APPROVED DRAWINGS HAVE BEEN RED LINED INDICATING A CHANGE TO MEET THE OBC. PLEASE REVIEW ALL PAGES TO ENSURE YOU ARE PROPERLY INFORMED OF CHANGES.

### TOWNSHIP OF NORTH DUMFRIES BUILDING DEPARTMENT

## Tice River Homes

## Legacy

**BASEMENT PLAN ELEV. 'A'**

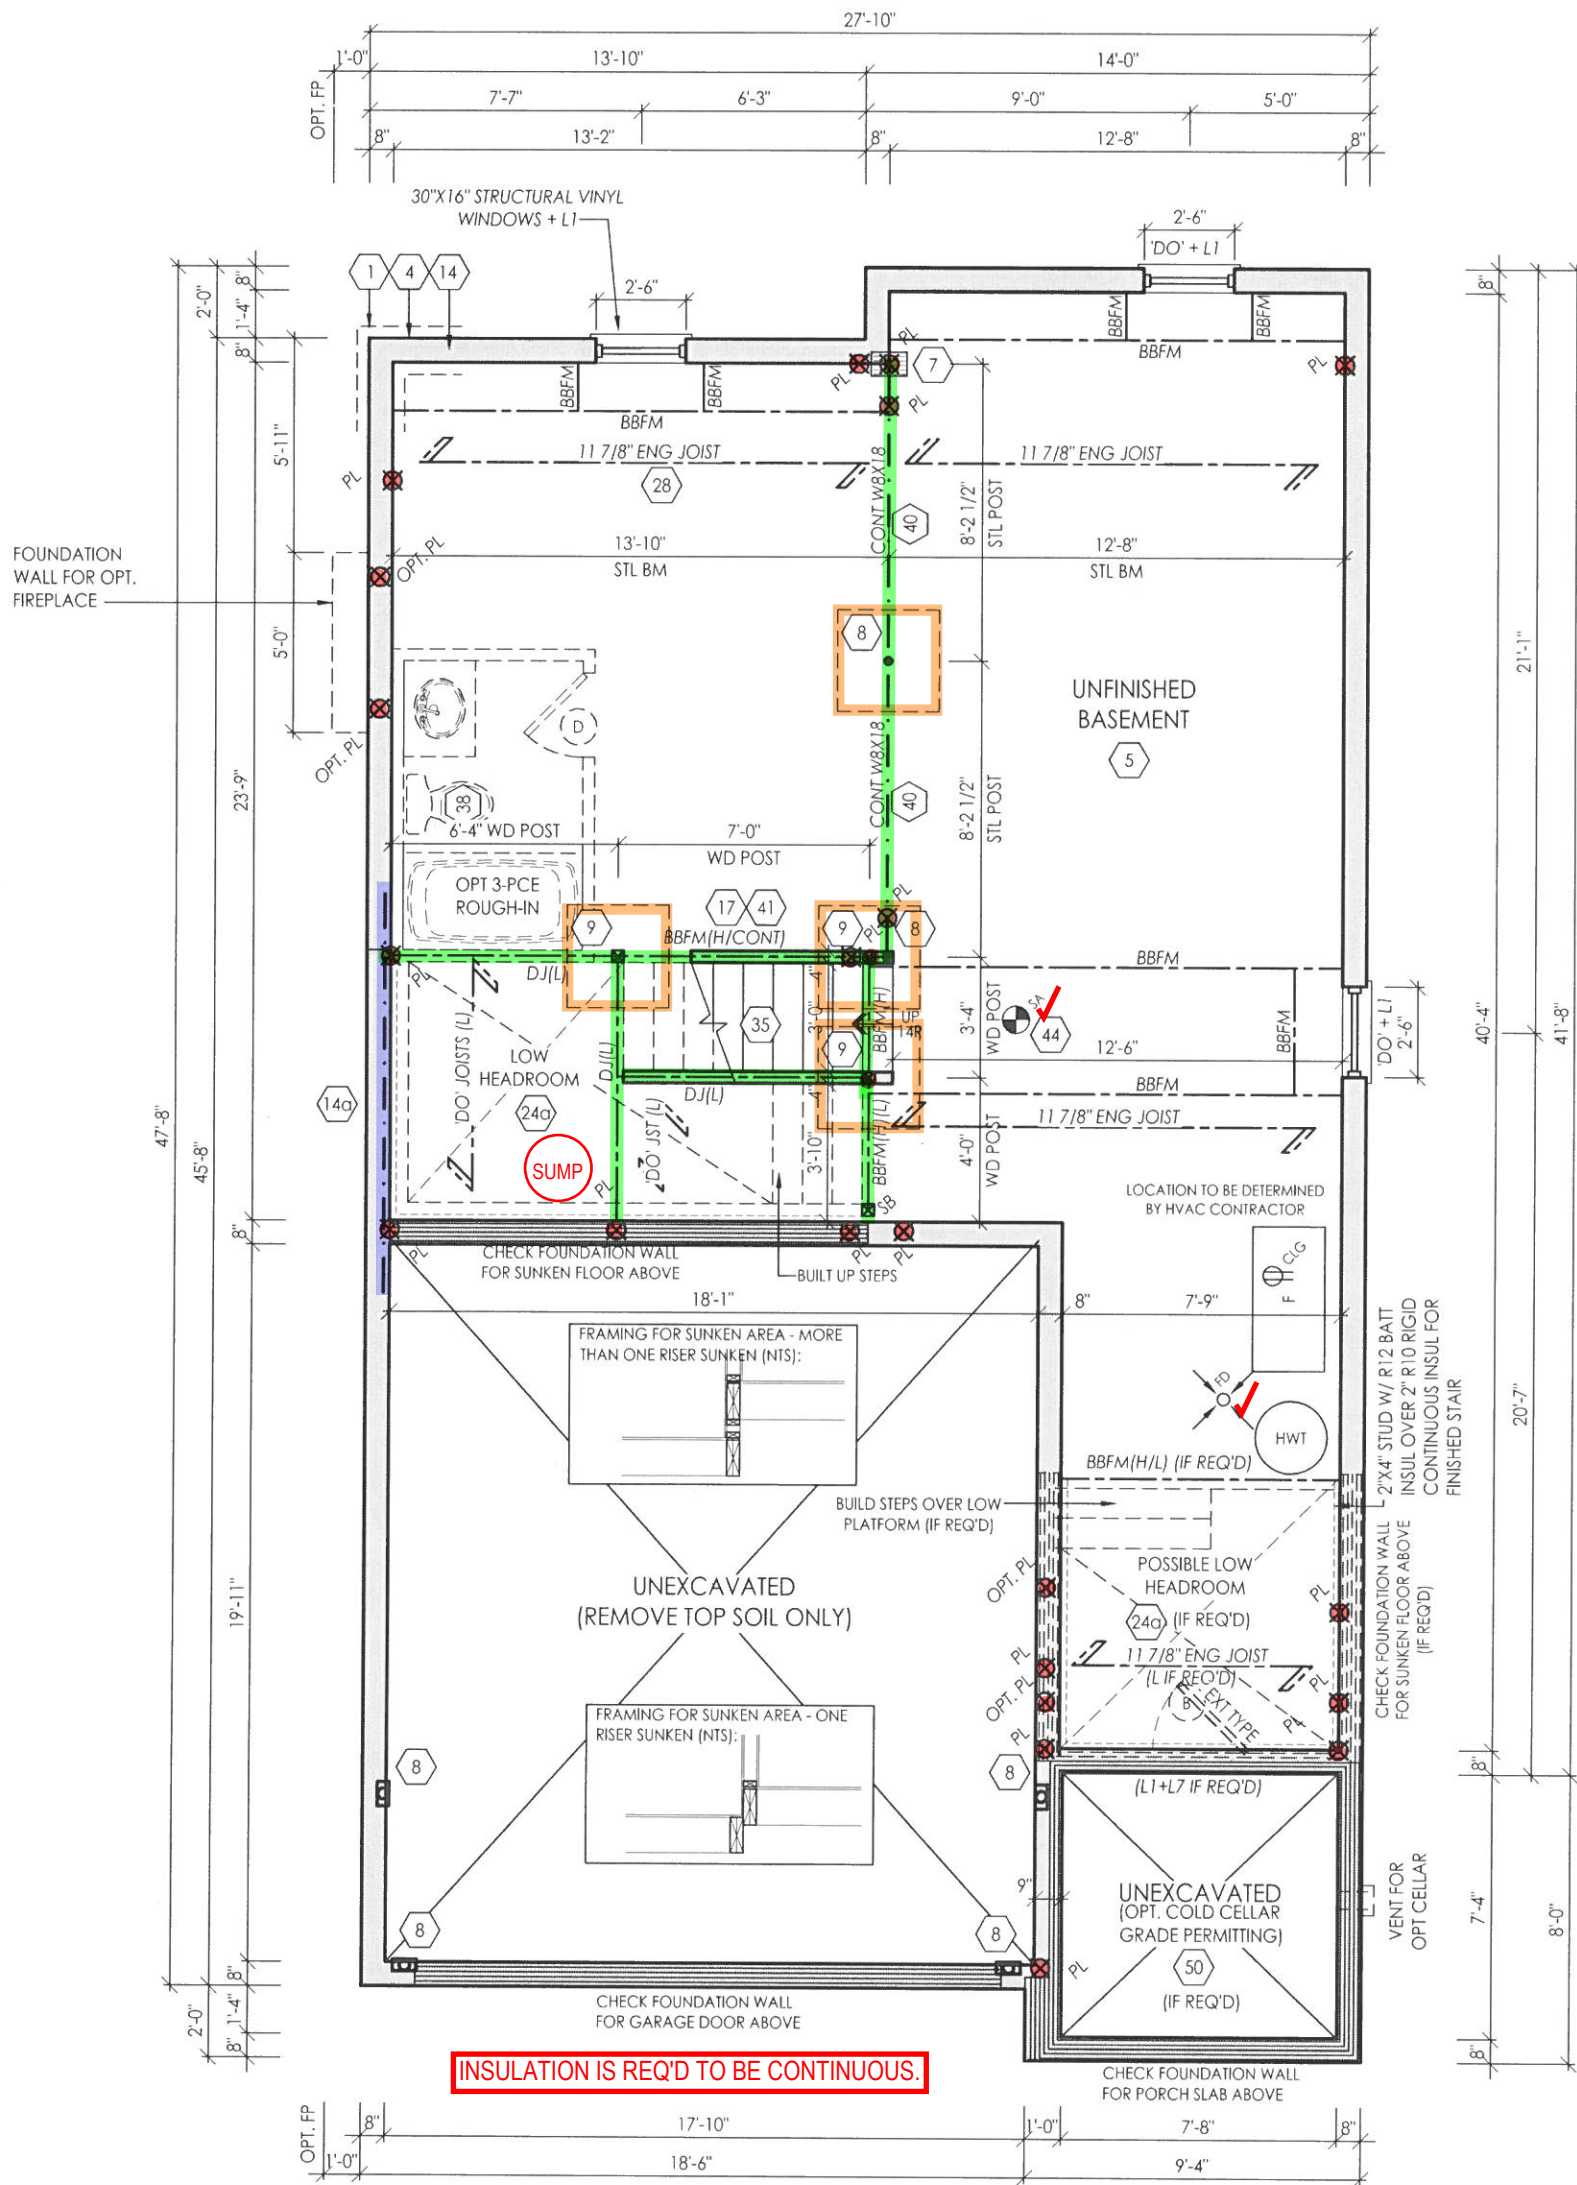
**SUMP PUMP/PIT SHALL BE INSTALLED AND CONNECTED ACCORDING TO LOCAL REGULATIONS.**

**SUMP PUMP LIDS, JOINTS AT INTERSECTIONS & ALL PENETRATIONS OF SLAB MUST BE SEALED TO PREVENT AIR LEAKAGE.**

**A SEPARATE BUILDING PERMIT WILL BE REQUIRED TO FINISH THE BASEMENT.**

**INSULATION IS REQ'D TO BE CONTINUOUS.**

**THE COLD CELLAR DOOR NEEDS TO BE INSULATED AND WEATHER-STRIPPED.**

**GROUND FLOOR ELEV. 'A'**

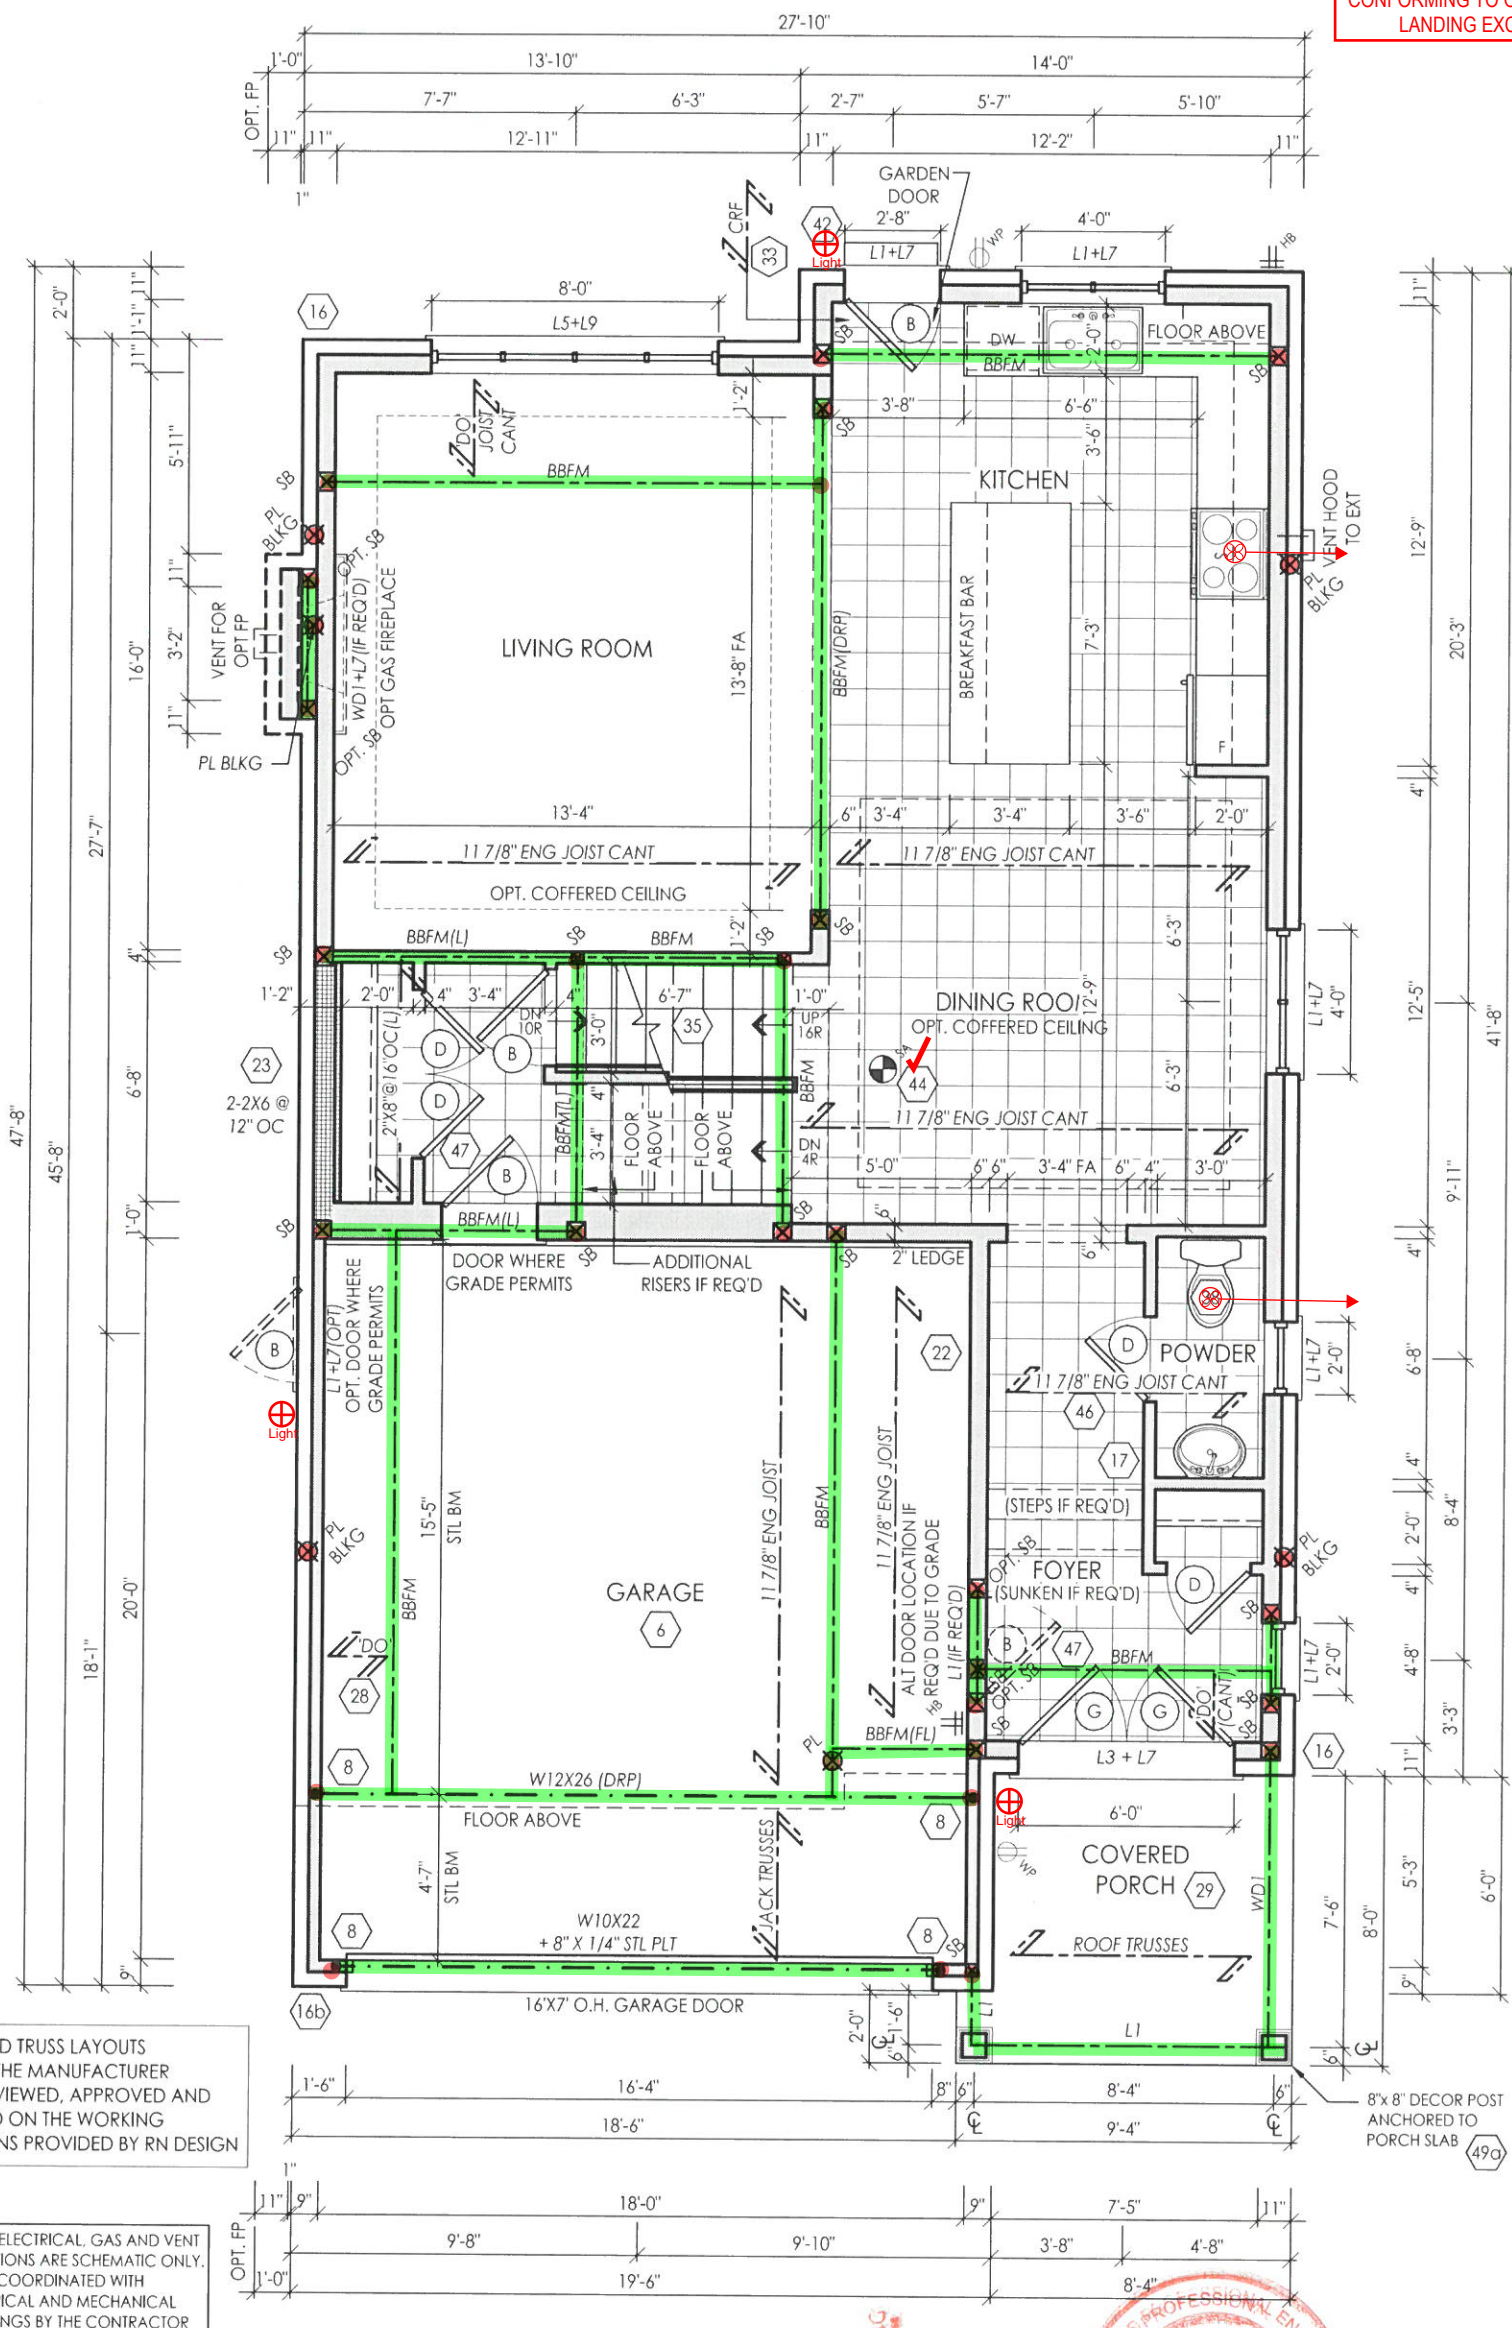
**SMOKE ALARMS WITH VISUAL ALARM ARE REQUIRED ON EACH FLOOR AND IN EACH BEDROOM INCLUDING A SMOKE/CO IN THE HALL THAT SERVICES THE BEDROOM.**

**2"X6" @ 16" o.c. WOOD STUDS CONTINUOUS FOR FULL HEIGHT c/w/ BLOCKING @ 48" o.c. or P.ENG DESIGN REQUIRED.**

**A LANDING IS REQUIRED AT THE ENTRANCE FROM AN ATTACHED GARAGE WHEN THERE ARE MORE THAN 3 RISERS BETWEEN THE GARAGE FLOOR AND THE INTERIOR FLOOR LEVELS IN ACCORDANCE WITH 9.8.6.2.(3)(a). GUARDS CONFORMING TO O.B.C. 9.8.8. & SB-7 ARE REQUIRED WHEN LANDING EXCEEDS 24" ABOVE GARAGE FLOOR.**

SECOND FLOOR ELEV. 'A'

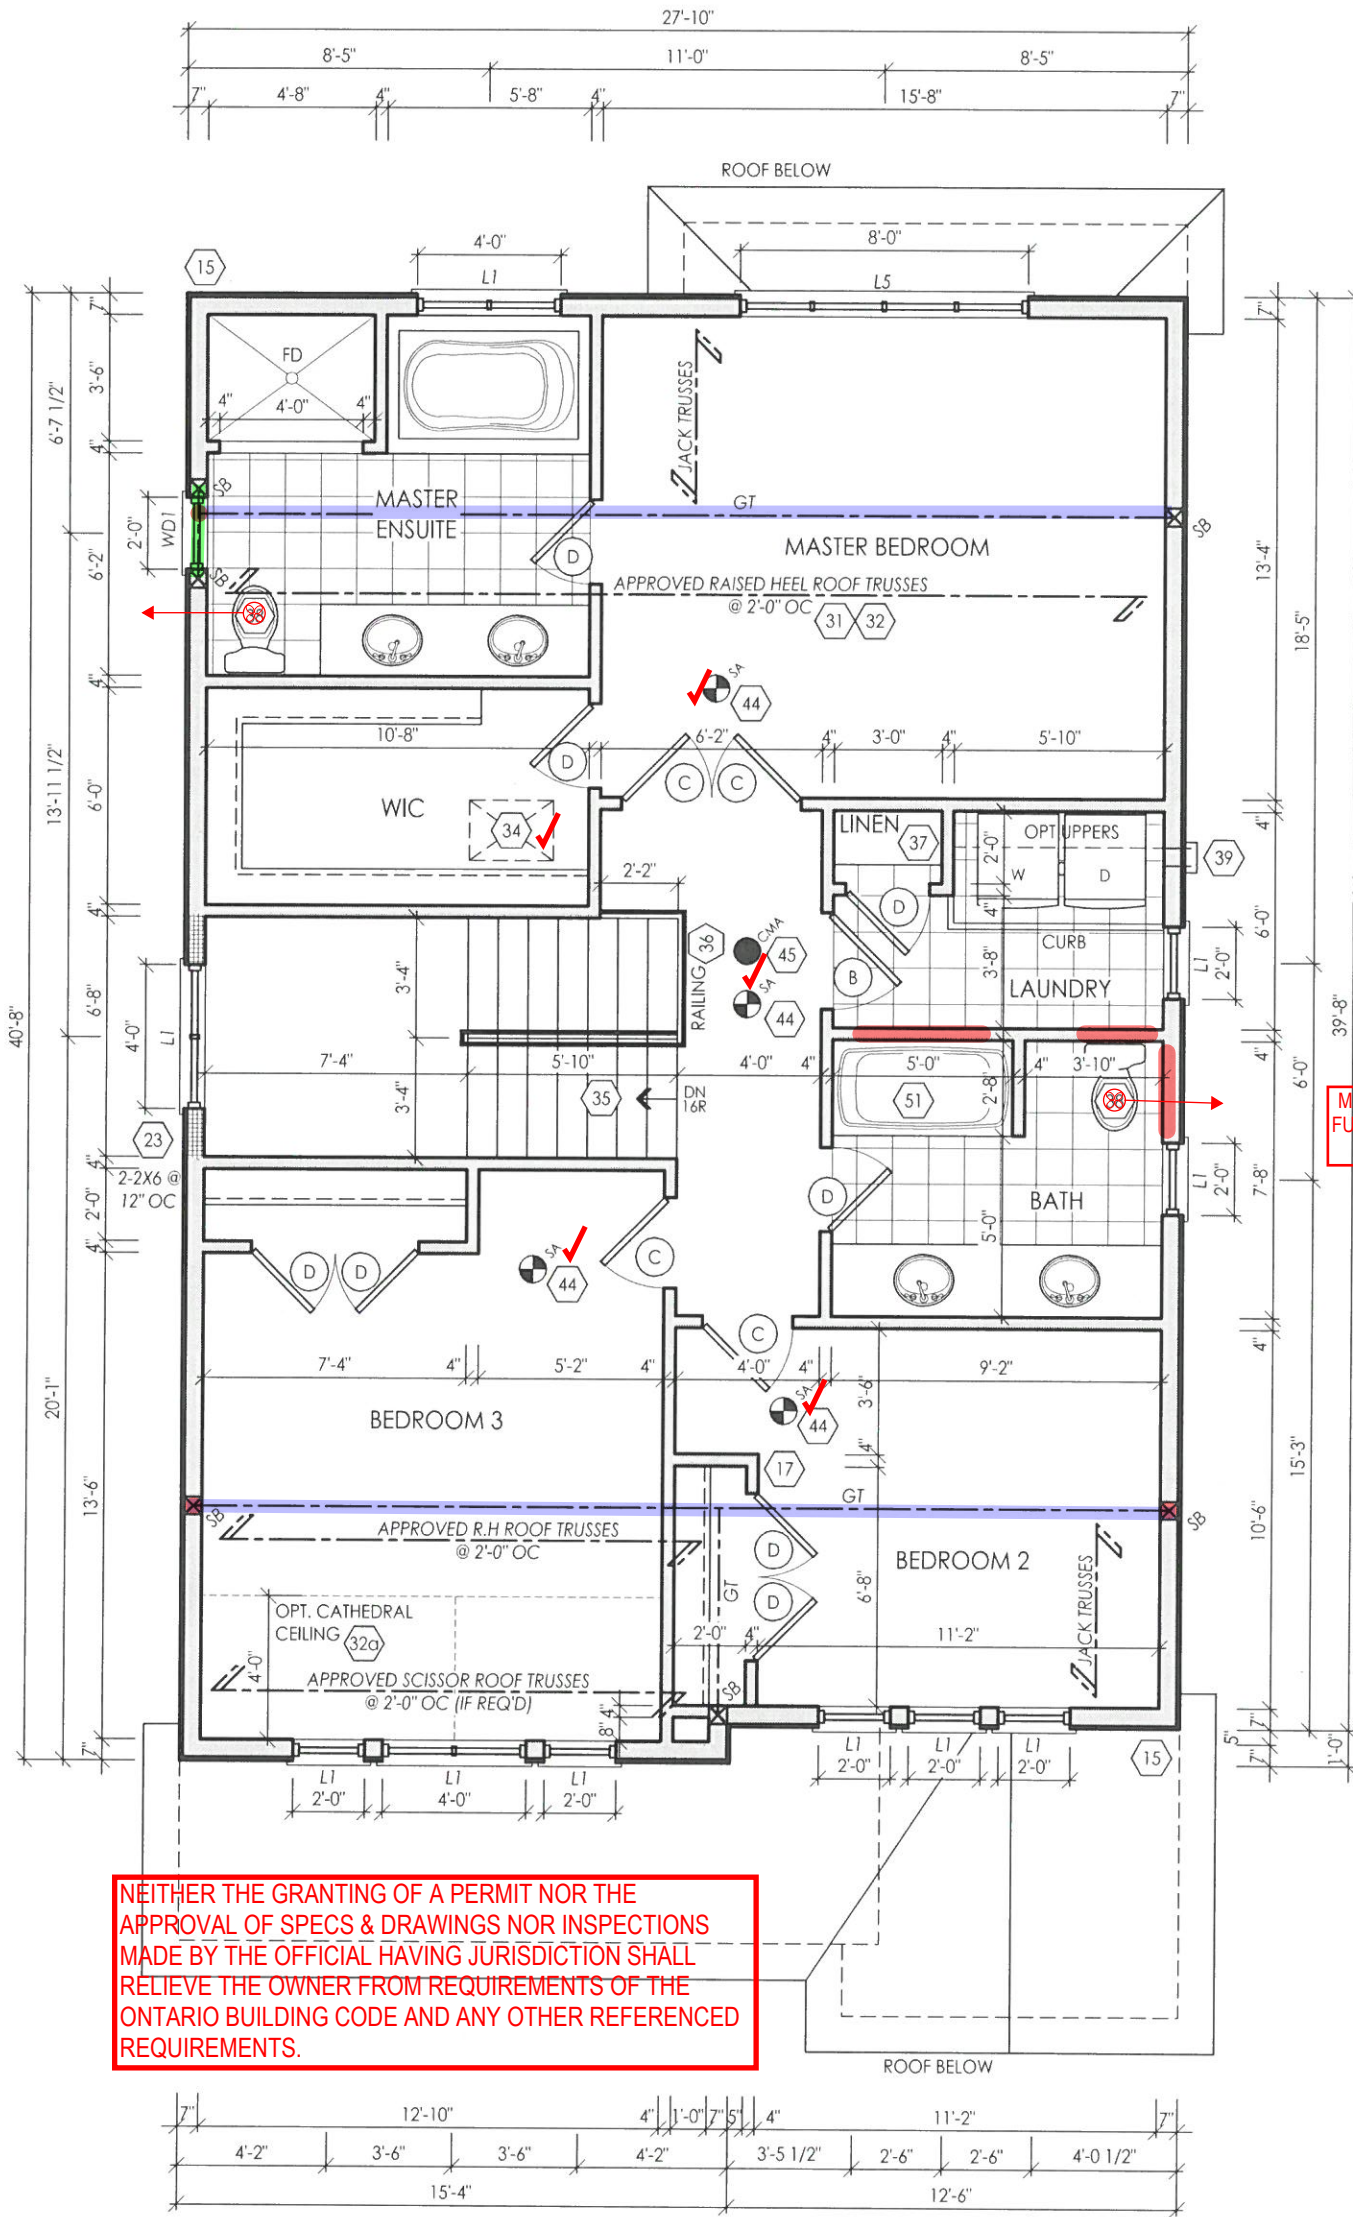
WINDOW SILL TO ME MINIMUM 2'-11" ABOVE STAIR/LANDING, OR BE PROTECTED BY A GUARD, OR BE DESIGNED TO WITHSTAND THE LOADS.

2"X6" @ 16" o.c. WOOD STUDS CONTINUOUS FOR FULL HEIGHT c/w BLOCKING @ 48" o.c. or P.ENG DESIGN REQUIRED.

SMOKE ALARMS WITH VISUAL ALARM ARE REQUIRED ON EACH FLOOR AND IN EACH BEDROOM INCLUDING A SMOKE/CO IN THE HALL THAT SERVICES THE BEDROOM.

AT LEAST 1 WINDOW SHALL PROVIDE AN UNOBSTRUCTED AREA OF 22" X 39" W/ A SILL HEIGHT MAX. 3'-3" ABOVE FINISHED FLOOR & 23'-0" ABOVE GRADE

MAIN BATHROOM TO HAVE STUD BLOCKING FOR FUTURE INSTALLATION OF GRAB BARS ADJACENT TO SHOWER/TUB AND TOILET.
